REVIEW OF WATERFORD III BASEMAT ANALYSIS

Structural Analysis Division
Department of Nuclear Energy
Brookhaven National Laboratory
Upton, NY 11973

June 21, 1984

FIG 4 BOUNDARY CONSTRAINTS.

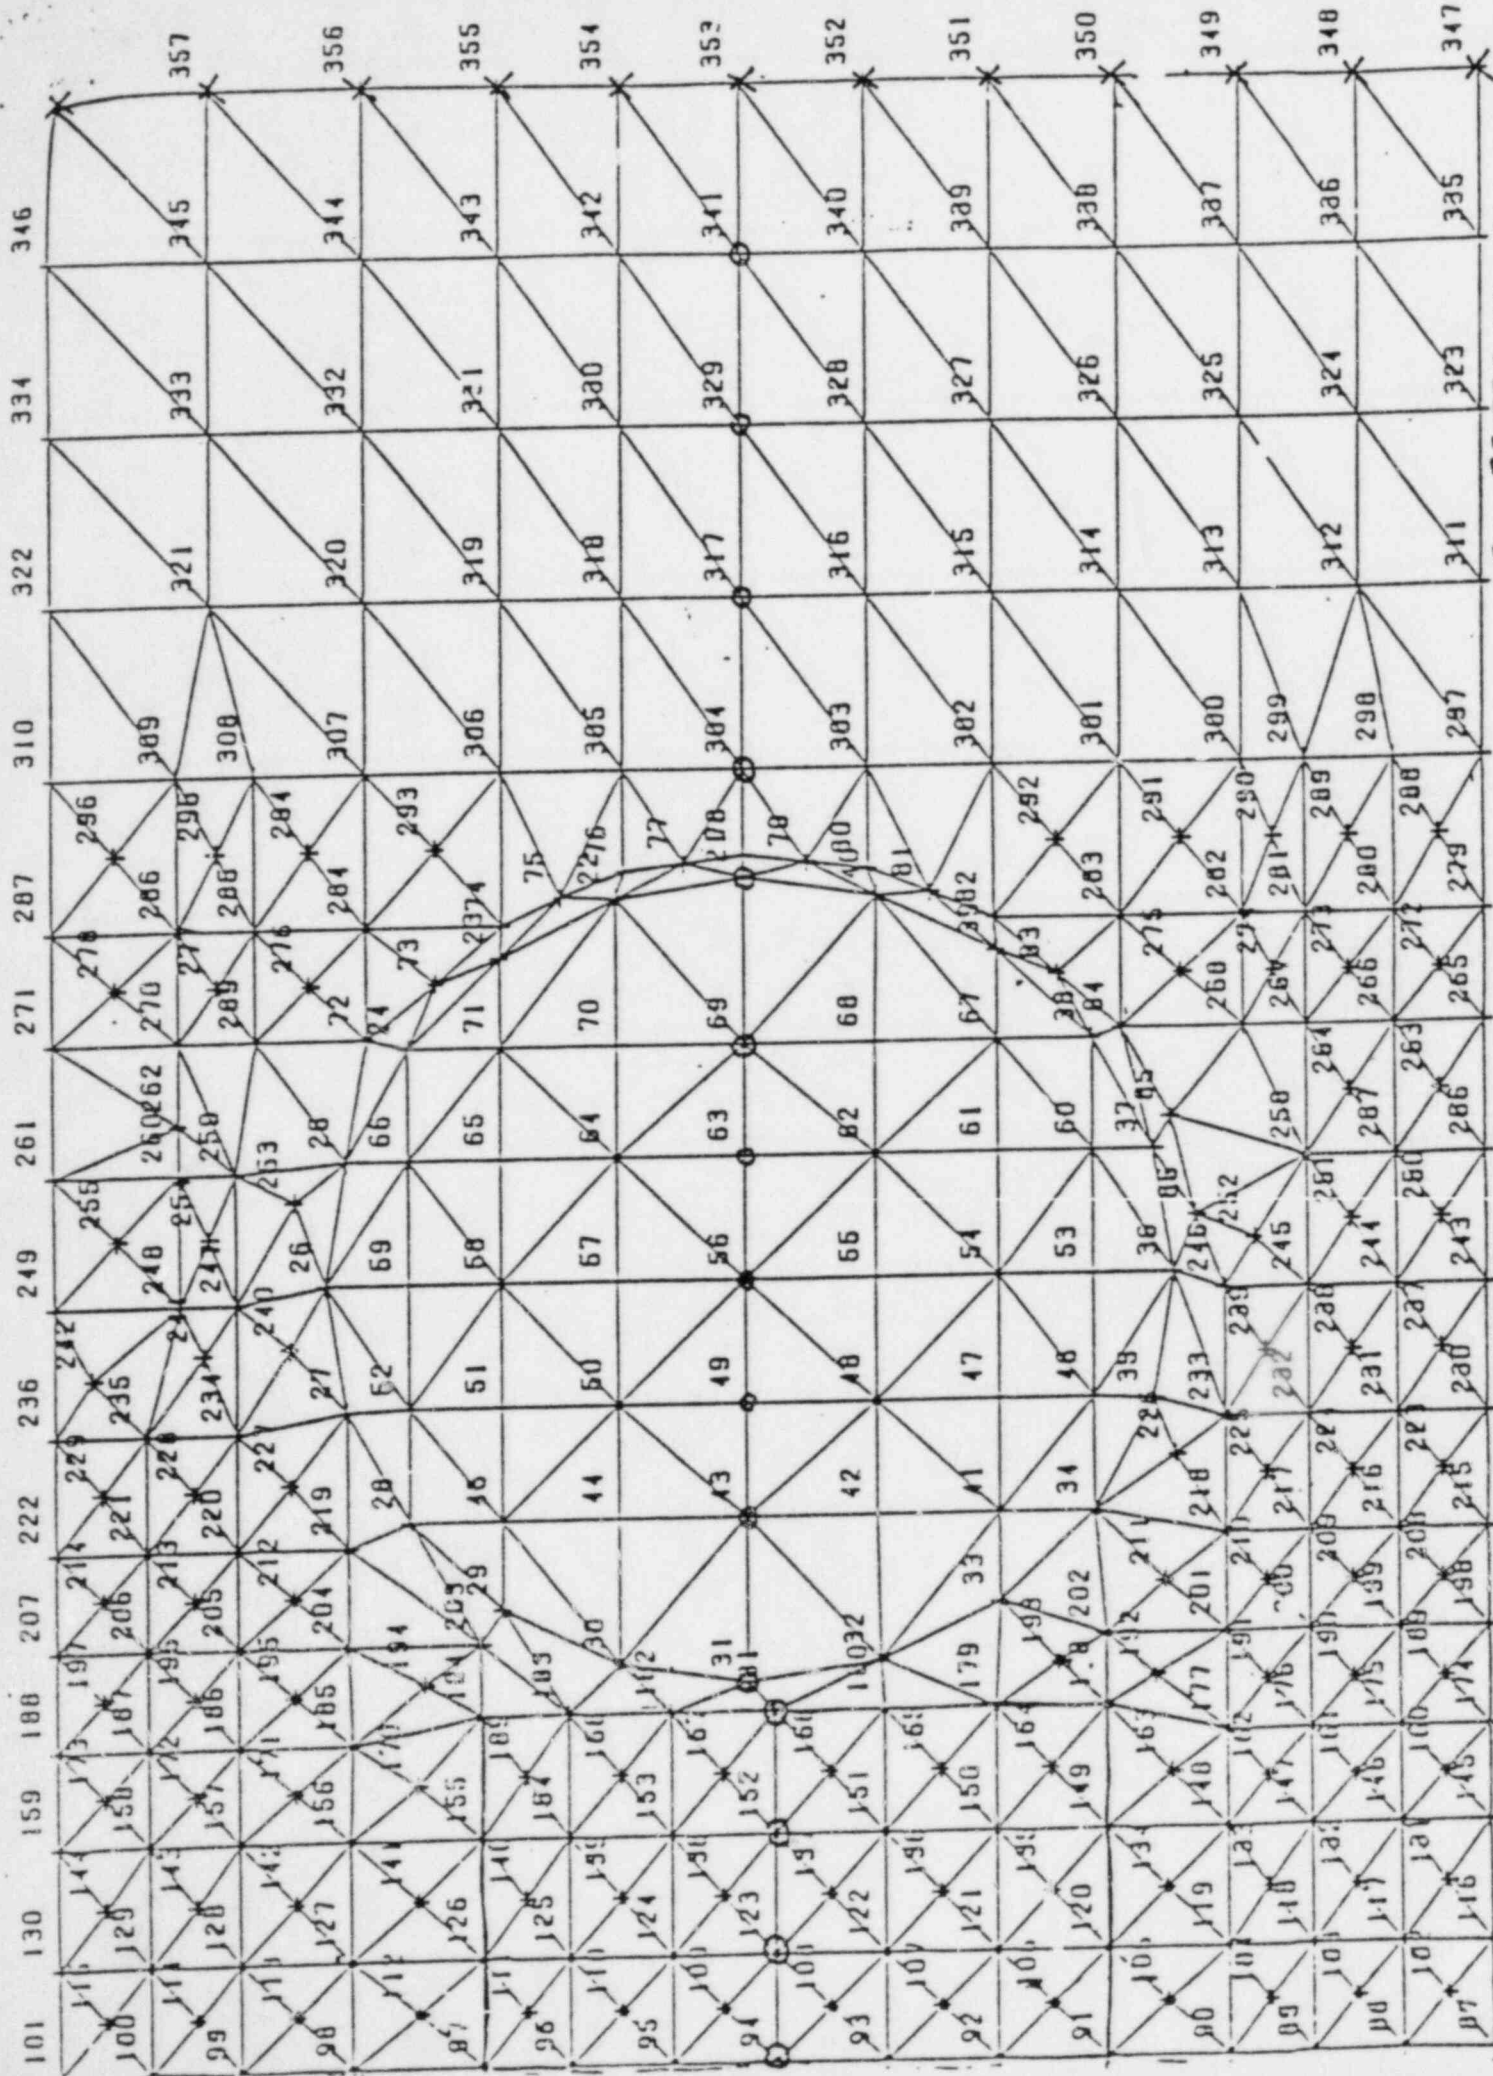
For equilibrium calculations no special consideration need be made for vertical case since the soil springs prevent unbounded structural motion. However, the same cannot be said for the horizontal case since soil springs are not used to represent the soil reactions. Rather the lateral soil forces are directly input to the model. To prevent unbounded rigid body motion, artificial lateral constraints must be imposed on the model. The constraints are depicted in Fig. 4. The nodes shown circled were constrained from movement in the y direction, while those described by "x" were constrained in the x direction. As commonly practical in finite element applications, the constraints are placed in a manner that they do not overly affect the static and dynamic response calculations. From the output presented in the EBASCO and HEA reports, it is not possible to evaluate the impact of the above shown boundary assumptions. The stresses caused by the artificial boundaries should be calculated and compared with those presented.

In general finite element models for plate structures require at least four elements between supports to obtain reasonable results on stress computations. The models used by both EBASCO and HEA violate this "rule of thumb"

Fig. 1 Construction of Two Adjacent Blocks

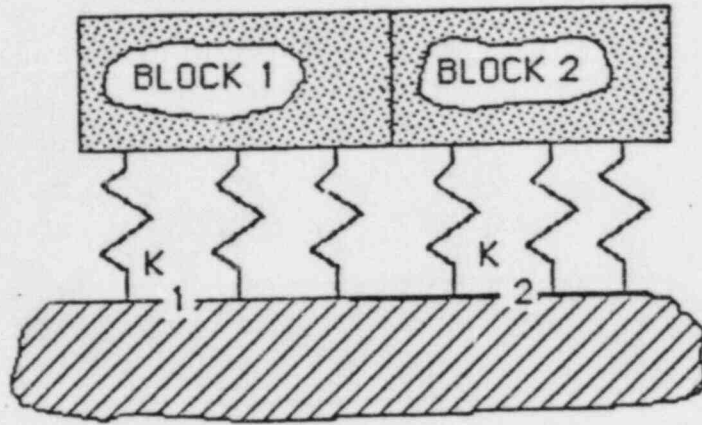
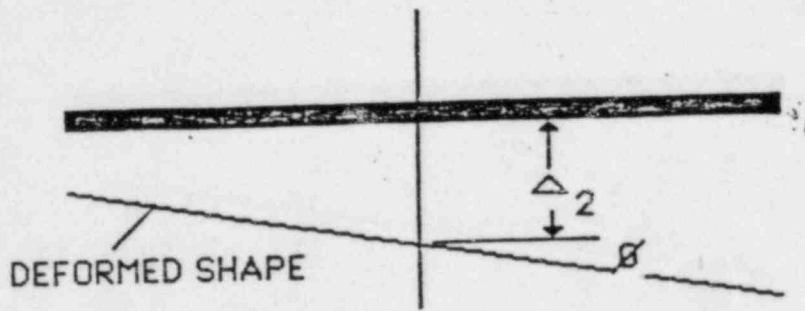
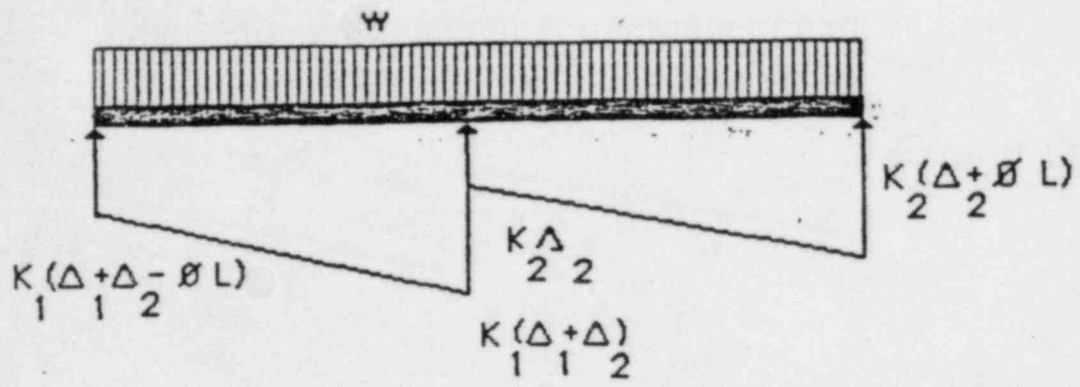
A question has been raised concerning the stresses which could have been introduced when the basemat blocks were being poured. The response of two adjacent blocks during construction are considered. The first block is taken to be in place when the second block is placed. It is also assumed that the concrete in the second block hardens immediately so that it can transmit loads to the first block. The subgrade modulus under the two blocks is assumed to be different so that the effect of soft spots in the soil can be considered. A sketch of the problem to be considered is shown in Fig. 1.

The second block is then poured. If the concrete is conservatively assumed to harden before the soil settlement can occur, the second block will introduce additional loadings on the first block. The new deformation caused by the weight of the second block is shown on Fig. 2.

The loads acting on the block may then be determined by multiplying the deformations by the foundation moduli. These loads are shown on Fig. 3. Force and moment equilibrium allow the two unknown displacements (Δ_2, ϕ) to be calculated. The results are,

Fig. 1 Estimated Side Loads On Wall

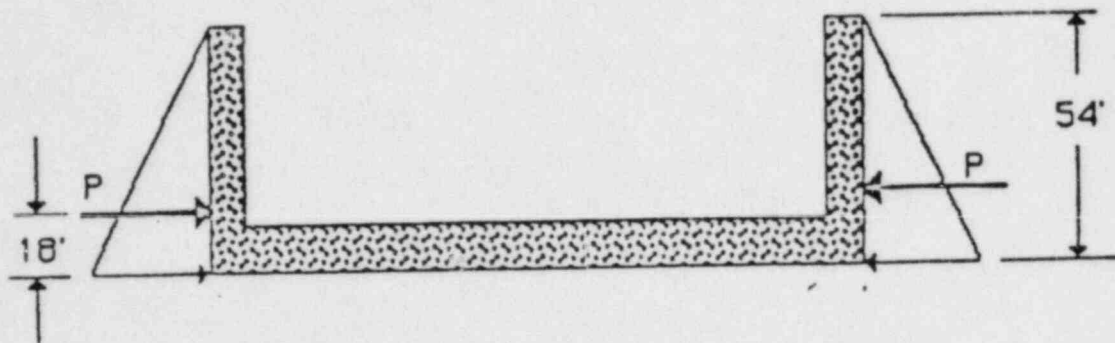
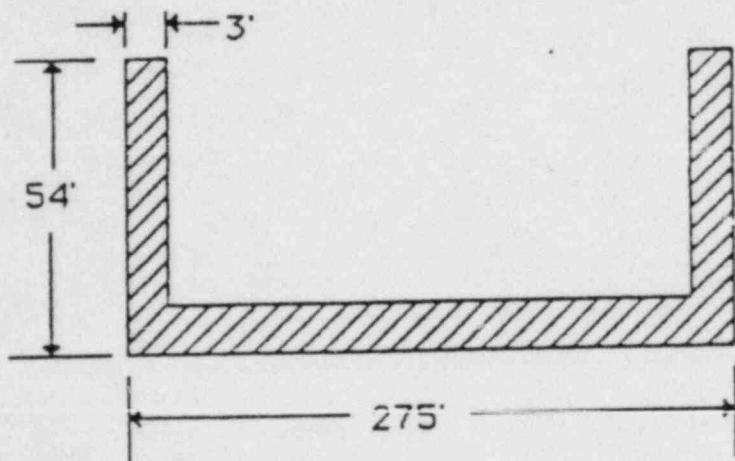
Table B.1 lists the horizontal loads which act on the sidewalls due to the various load combinations. These loads were determined directly from the HEA/Ebasco computer printouts. An elevation of the structure parallel to the long direction of the basemat is shown on Fig. B.1. The forces (P) are taken as the forces shown on Table B.1 and acting on walls #2 and #4. The soil pressure is assumed to have a triangular variation as shown so that the resultant force (P) acts at the third point on the wall. Since the wall is buried about 54', the resultant force acts at a point 18' up the wall from the bottom of the basemat.

The stresses caused by this loading in the cross section shown on Fig. B.2. The basemat is analyzed as a beam structure. The cross section shown in Fig. B.2 has the following properties:
